M E M O

Subject: Acceptance of late submission from APRL on behalf AREF (Sydney

6 & 8 Parramatta Square - Lot 2 DP 1234735, Lot 3 DP 1234735, Lot 4

Proposal: Construction of a basement carpark for the commercial premises and function centre (PS6/8)

Image 5: Extract from the Traffix Arrangement option, adopting the approved ramp footprint of DA436/2016 with further modification of the carriageway width whilst remaining within the existing reserve of Darcy Street.

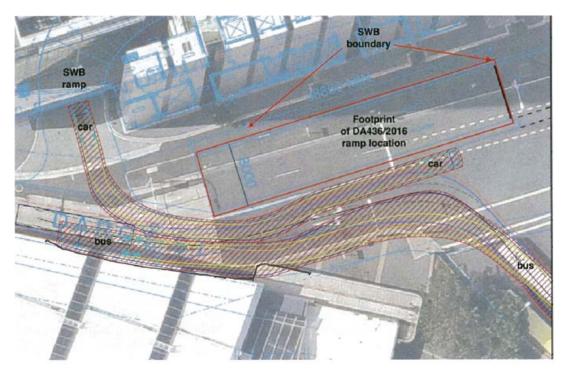
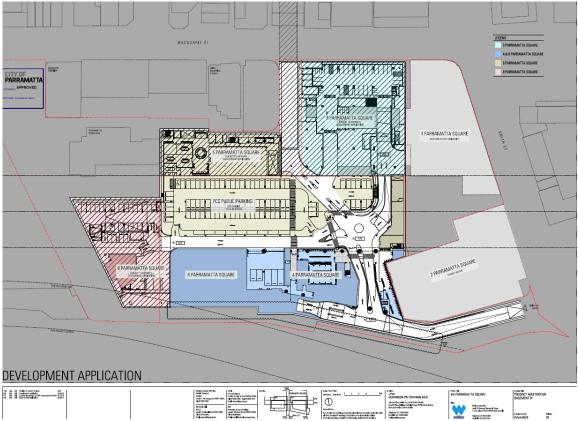
The ramp is to be constructed in the location the objector desires, which makes their objections a moot point. In their first objection letter dated 1 June 2018 they refer to "image 5" which shows the traffic arrangement outcome they want to achieve and which they say is consistent with that approved under DA 436/2016 as modified to date. As already noted, Walker has been issued with a CC to construct the ramp as per DA 436/2016 modified to date.

The image shows that the ramp is located in a configuration that allows the occupants of the Sydney Water Building to exit left out of the building whilst at the same time the buses in the layover facility can turn left and head west down Darcy Street.

Putting aside the fact that the Transport authorities and Council's traffic planners have all stated they do not support the Sydney Water occupants retaining their ability to exit left because traffic modelling does not support this movement, the exit left as desired by Sydney Water presents other problems.

We have indicated these problems on the drawing below. The drawing shows the heritage awning of the Parramatta Railway Station will need to be cut back and the footway on the southern side will need to be deleted. None of these outcomes have approval or have been assessed.

DA 436/2016: DA-A-0504 Rev.03 (Basement Level 01)

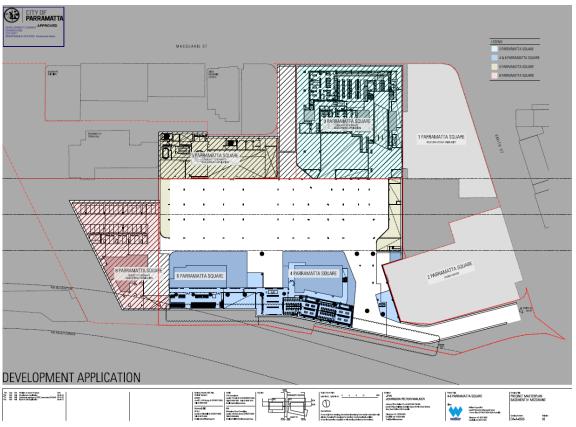
- Walker is in error regarding its claim to the Sydney Central City Planning Panel at the meeting on 04 July 2018. Walker stated to the Panel, the difference in the position of the ramp was due to the different levels on the drawings. At the meeting the Panel determined modification (H) to DA 436/2016. AREF had lodged an objection to the proposed modification. One of their objections was that the plans (both original and modification) were inconsistent when illustrating the location of the dive structure (ramp) and that recent approved plans opened up the opportunity for east bound access to be available. Modification H did not seek to amend the Sydney Water access or location of the dive structure to the super basement.

The location of the dive ramp is shown on the following stamped approved drawings under DA 436/2016 (modification E): DA-A-0504 Rev.03 and DA-A-0505 Rev 03.

JPW confirm detailed documentation for the ramp (developed for DA 436/2016/E), has progressed on the basis of the location shown on the approved drawings DA-A-0504 Rev.03 and DA-A-0505 Rev 03.

DA 436/2016: DA-A-0060 Rev.02 (Site Plan)

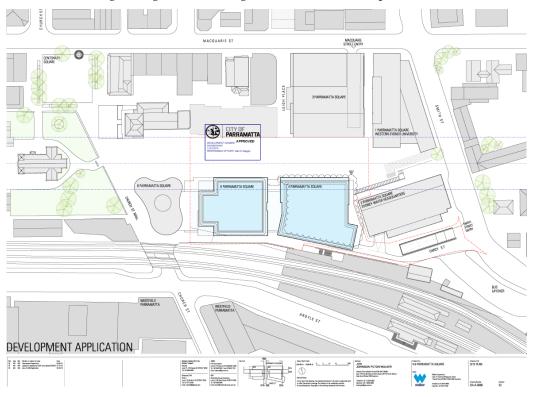
The discrepancy in the drawings arises from the location of the ramp shown on the site plan (DA-A-0060 Rev.2). The ramp is shown setback from the Sydney Water boundary thereby making it difficult to accommodate Sydney' Water's desired left exit. In any event, the objector does not support the location of the ramp shown on the site plan.

Upon review the architects – JPW acknowledge there is a discrepancy between the site plan and the basement drawings in regards to the alignment of the dive ramp.

Subject to direction from Council, JPW can address the discrepancy found on the site plan affecting DA 46/2018 as well as those affecting DA 436/2016/H, and reissue the subject documents to avoid ongoing confusion.

Development Application 46/2018 DA-A-6-0504B and DA-A-6-0505B.

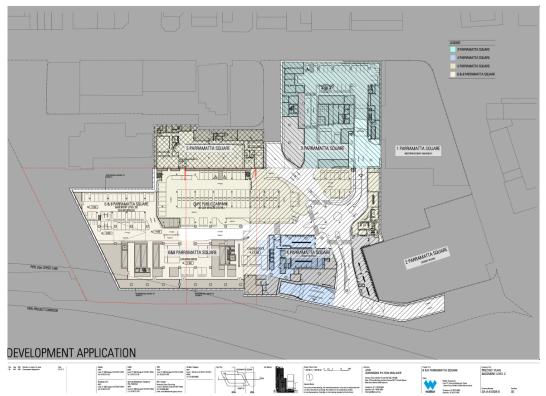
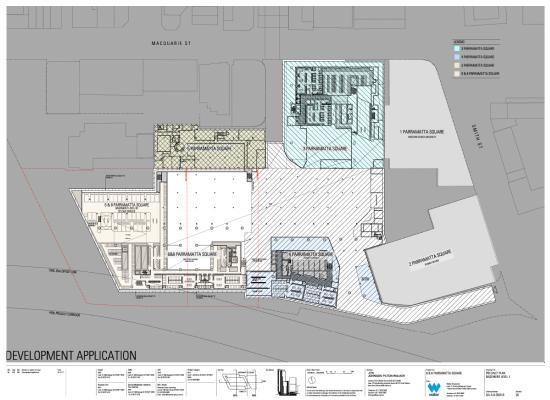
- The second claim is for the plans to be amended to reflect the dive ramp arrangement depicted on DA-A-6-0505-B which would allow retention of the existing two-way vehicle movement between the existing basement car park ramp of No. 2 Smith Street and the intersection of Smith Street and Darcy Street.

This is consistent with the ramp location shown under Development Application -46/2018 and drawings DA-A-6-0504B and DA-A-6-0505B.

Annexure B – Objector letter dated 24 July 2018

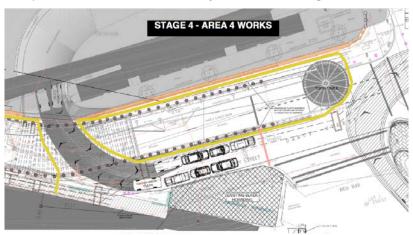
The objector has provided a drawing which they assert is the construction plans for the ramp and which confirms associated two way vehicle movement from the Sydney Water building to the intersection of Darcy Street and Smith Street alongside the dive ramp.

The plan is part of a series of staging diagrams provided to Sydney Water and were prepared for the interface works with the Sydney Water driveway during construction of the ramp. The staging plans were prepared through workshops between the builder, Transport Authorities, Sydney Water and Parramatta City Council.

The diagrams of which one is shown in this letter depict how access can always be maintained to the Sydney Water building in a temporary arrangement during construction works. However, in certain instances the access to the basement entry must be reduced to a single lane in and out to enable the physical construction of the ramp.

I confirm the arrangement is only temporary so as to enable the swept paths to work and will require the footpath on the southern side of Darcy Street to be utilised to cater for these vehicle movements. The swept paths have been developed on the information provided by Sydney Water in relation to their typical vehicle types which utilise this entry into their basement.

This temporary setup is envisaged to be in place for a period of time until the traffic signals on the corner of Station Street and Darcy Street can be amended to its final design, the ramp is completed and the civil works to the length of Darcy Street are finished. At this point in time the temporary configuration will be swapped over to the final configuration.

52. From the overlay image provided:

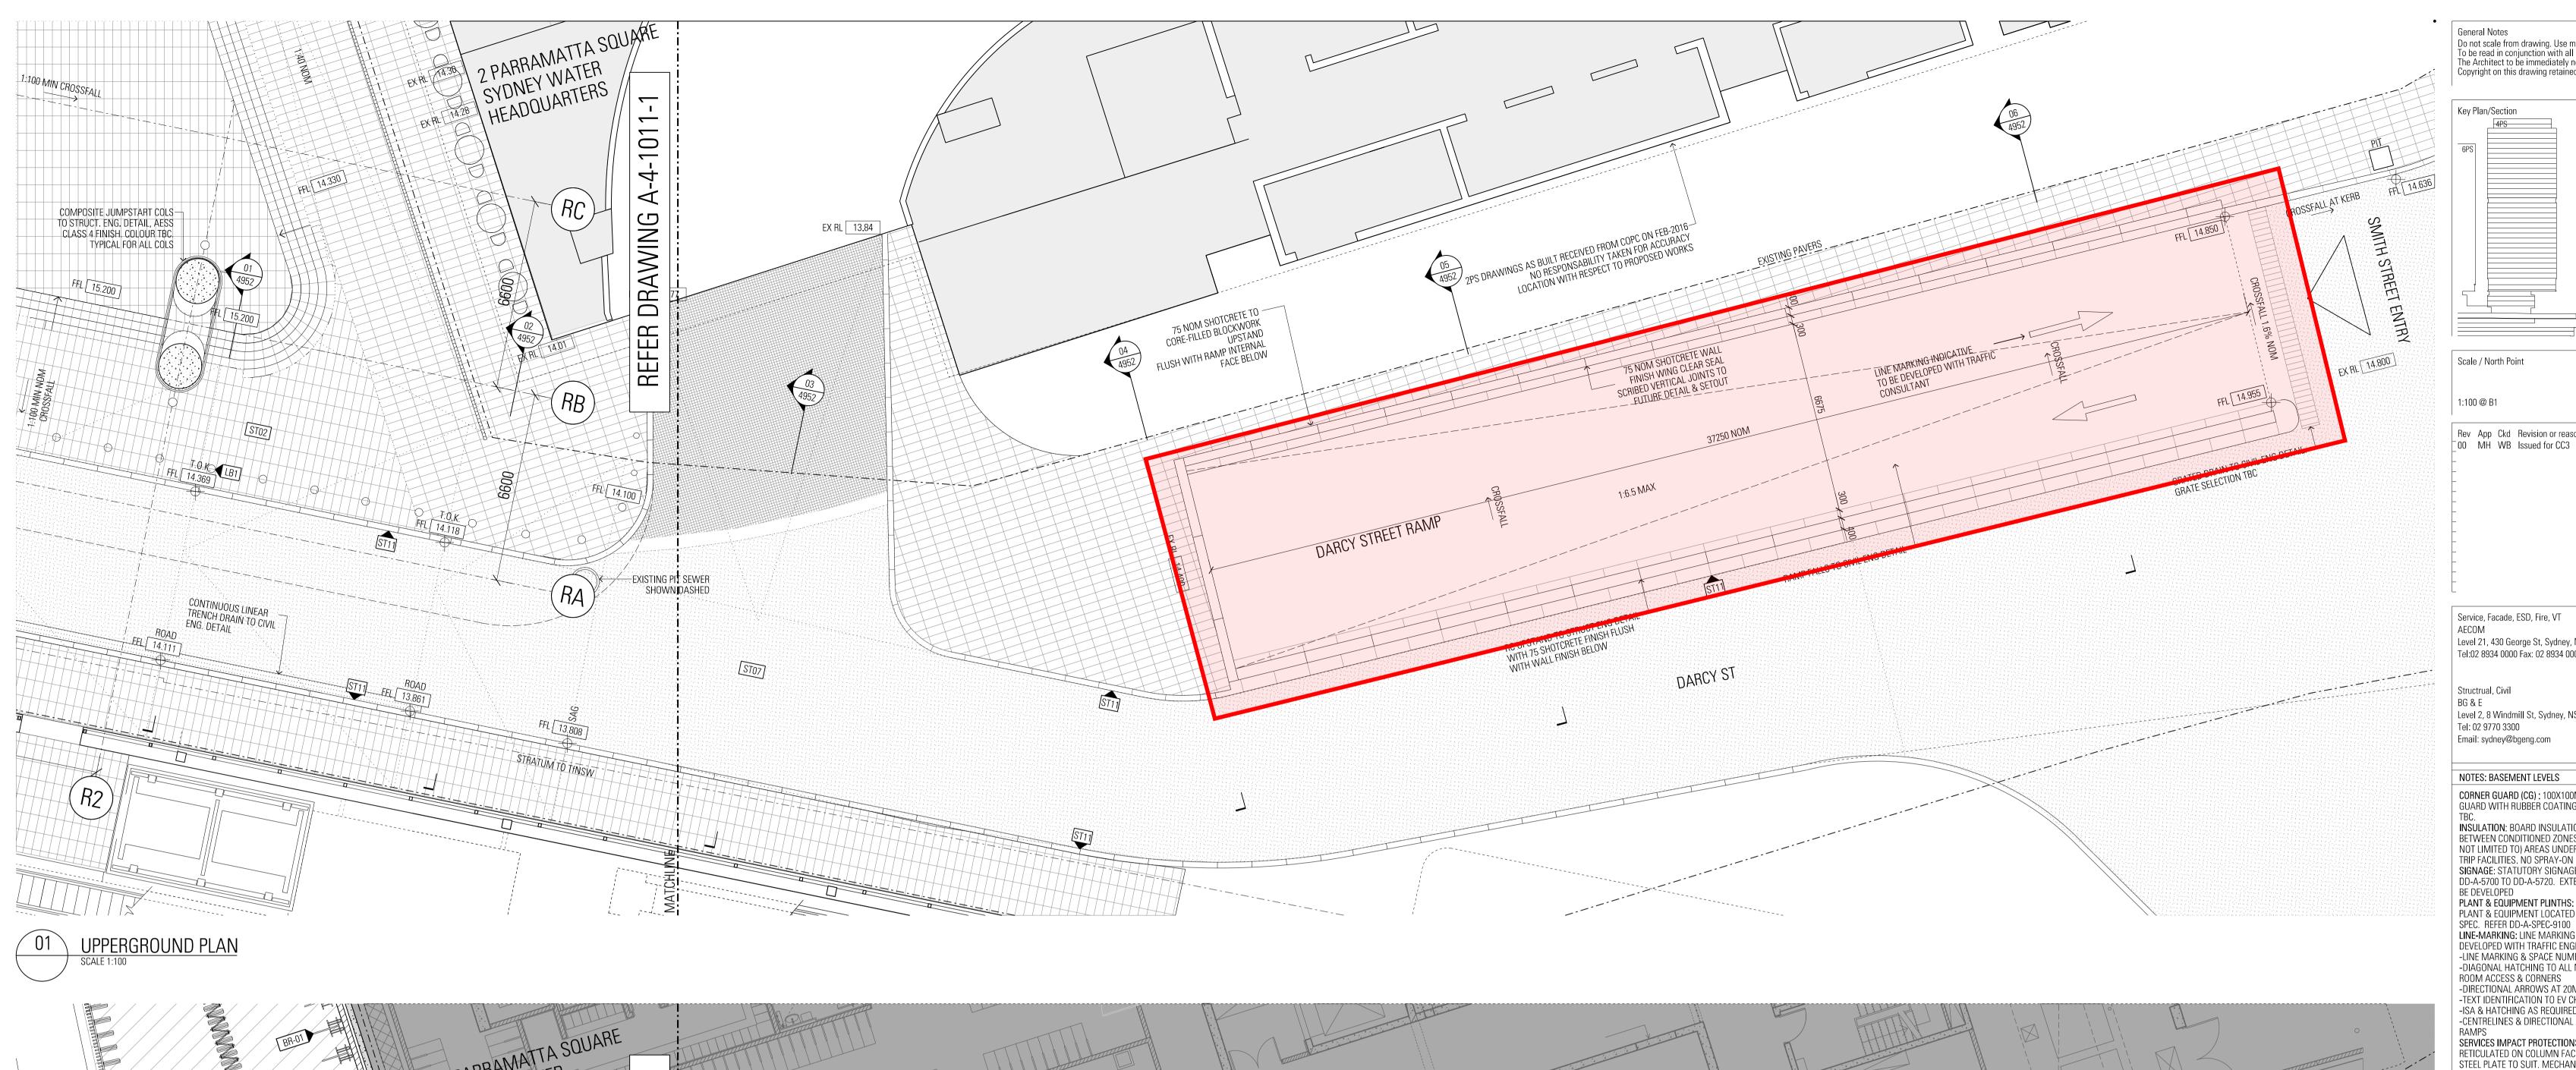
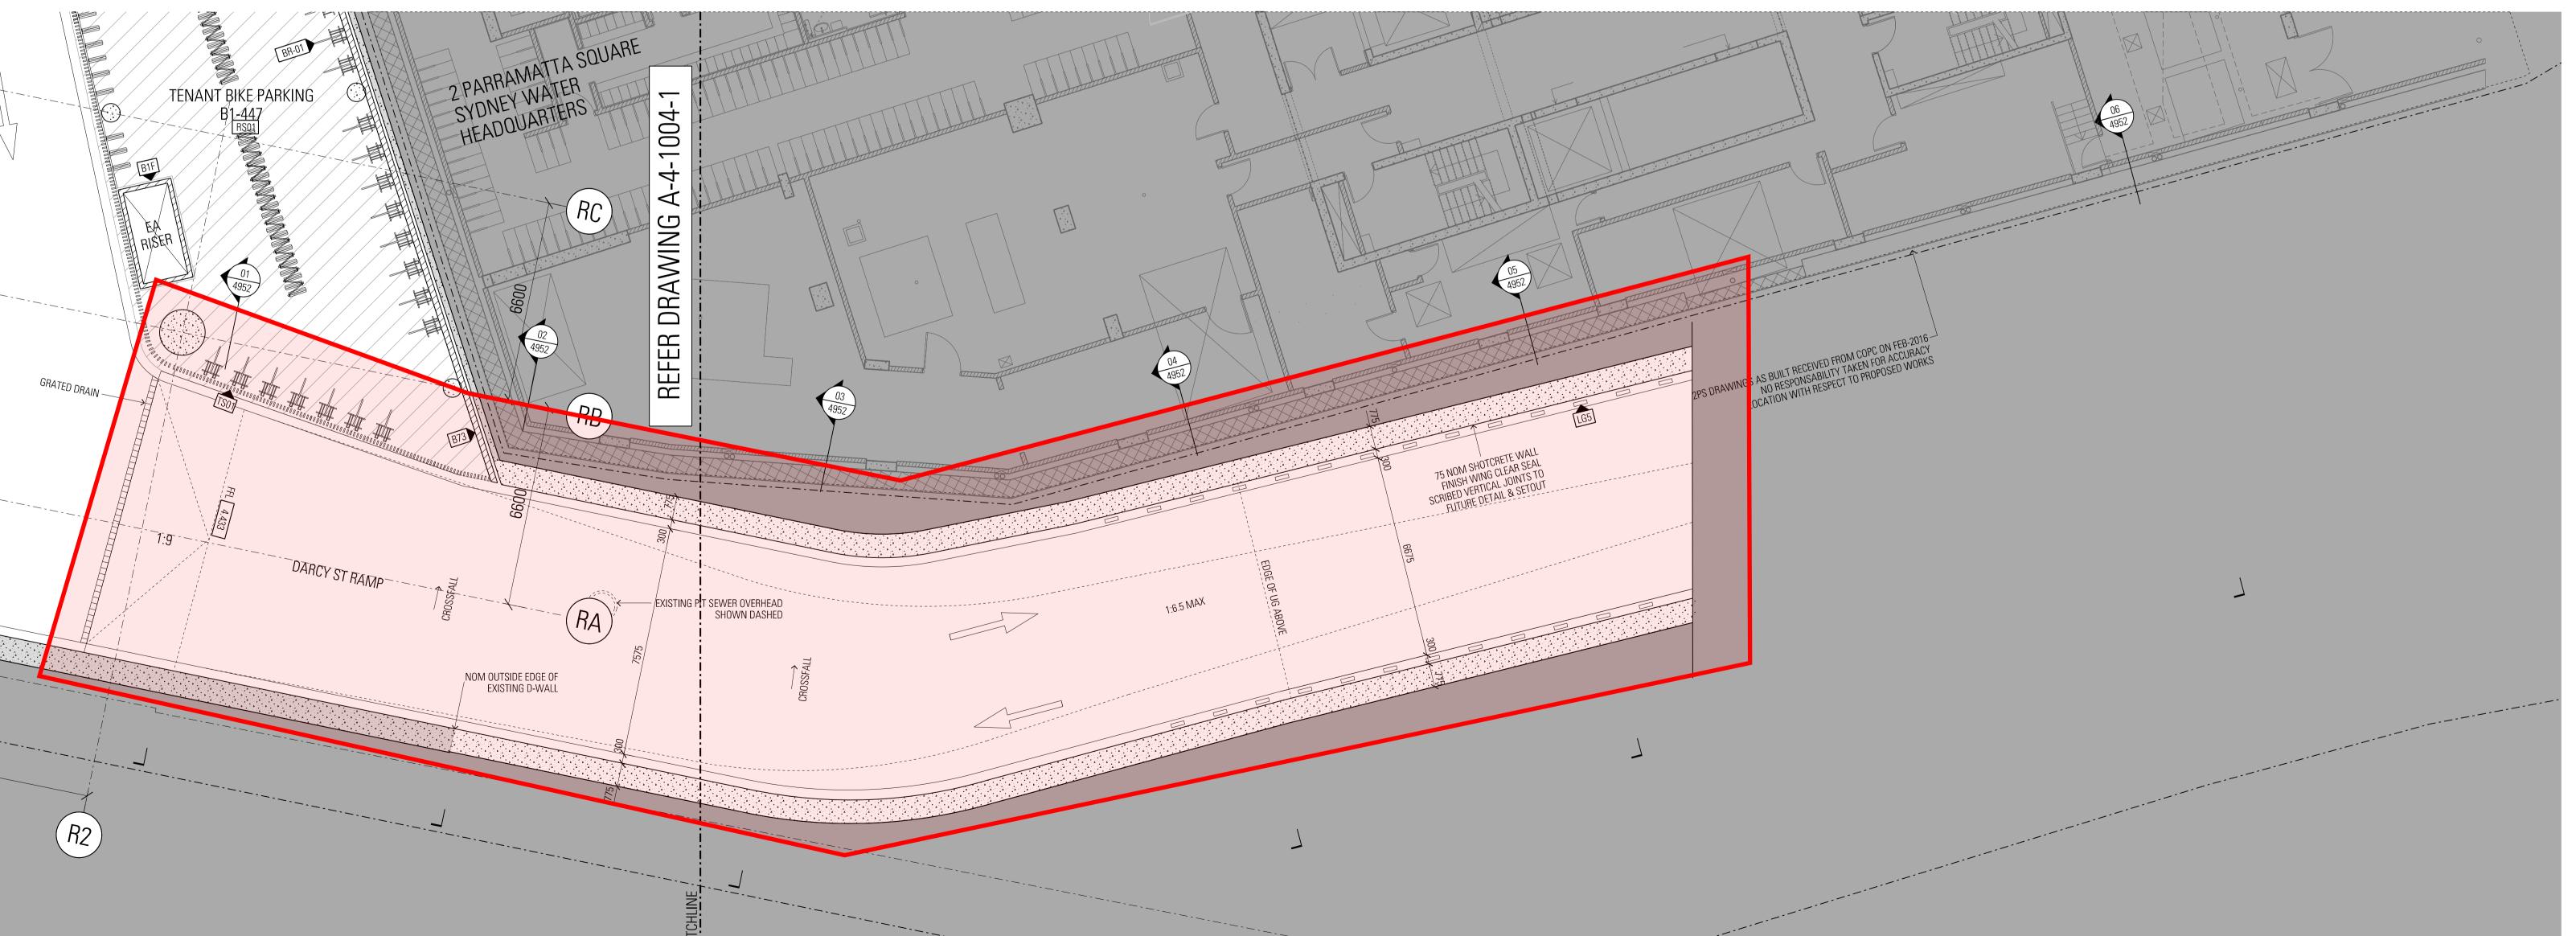
- a. a ramp footprint with a similar alignment to the approved Rev E ramp footprint will have a lesser impact upon existing two-way movement from the SWB ramp compared to the submitted proposal. The Darcy Street ramp can be relocated to that location;
- b. the road carriageway width between the eastern edge of a relocated ramp footprint (as per the Rev E alignment) and the south edge of the road reserve can be widened to about 7.0-7.1m, sufficient in width to enable two-way movement, including for a westbound bus when a car is leaving the SWB ramp.
